Access Compliance Report Public Rights-of-Way (Curb Ramps)

Main Street: CECIL_PASTURE_RD Cross Street: N/A Location: S

ADA ID: RPRK211026122833 Ramp Type: Type 1 - Perpendicular Initial Pass/Fail: Fail Overall Compliance: No Severity Score: 15

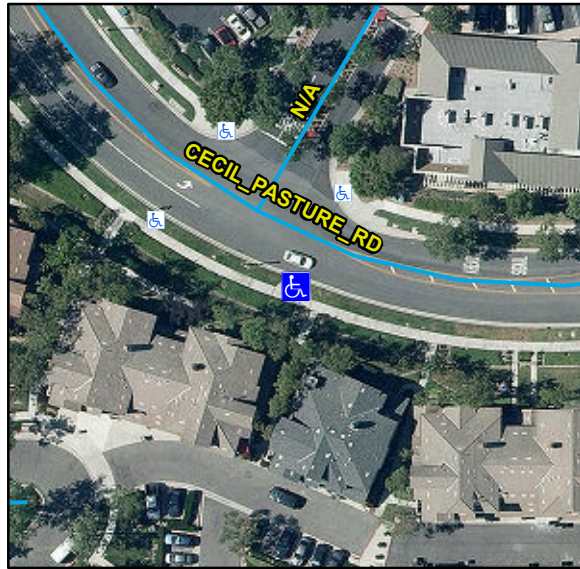
Compliance	Description	Data	Compliance	Description	Data
N/A	Ramp Length (in)	90	N/A	Flare Type LT	
Yes	Ramp Width (in)	48			N/A
No	Ramp Run Slope (%)	9.3	N/A	Flare Slope LT (%)	N/A
Yes	Ramp Cross Slope (%)	1.6	N/A	Flare Traversable LT	N/A
N/A	Landing Present	N/A	N/A	Flare Type RT	
N/A	Landing Length (in)	N/A			N/A
N/A	Landing Width (in)	N/A	N/A	Flare Slope RT (%)	N/A
N/A	Landing Run Slope (%)	N/A	N/A	Flare Traversable RT	N/A
N/A	Landing Cross Slope (%)	N/A	N/A	DWS Provided	N/A
N/A	Landing Movement Obstructed?	N/A	N/A	DWS Contrast	N/A
	Landing Movement Type	N/A	N/A	DWS Length (in)	N/A
N/A	Landing Shared	N/A	N/A	DWS Full Width	N/A
N/A	Clear Space	N/A	N/A	DWS Offset Left (in)	N/A
N/A	Clear Space To Crosswalk (in)	N/A	N/A	DWS Offset Right (in)	N/A
N/A	Marked Crosswalk 1	No	N/A	Marked Crosswalk 2	N/A
	Crossing 1 Direction	NE		Crossing 2 Direction	N/A
	Marked Crosswalk 1 Width (in)	N/A		Marked Crosswalk 2 Width (in)	N/A

N/A	Ramp Inside Crosswalk 1	N/A	Yes	Ramp Inside Crosswalk 2	N/A
	Crossing 1 Slope (%)	3.4		Crossing 2 Slope (%)	N/A
	Crossing 1 Cross Slope (%)	2.8		Crossing 2 Cross Slope (%)	N/A
N/A	Gutter Ponding	N/A	No	Curb Slope	10.3
Yes	Gutter Lip Height (in)	0		Road Run Slope (%)	N/A
N/A	Gutter Run Slope (%)	N/A		Road Cross Slope (%)	N/A
N/A	Gutter Cross Slope (%)	N/A			
Yes	Overall Surface Condition: Acceptable		No	Perp Joint Present	No
	Cross Gutter Present?	No		Spandrel Present?	No
	Replace Cross Gutter?	N/A		Replace Spandrel?	N/A

Remove & Replace Entire Ramp.

R304.2.2, R204.3, STD 1115
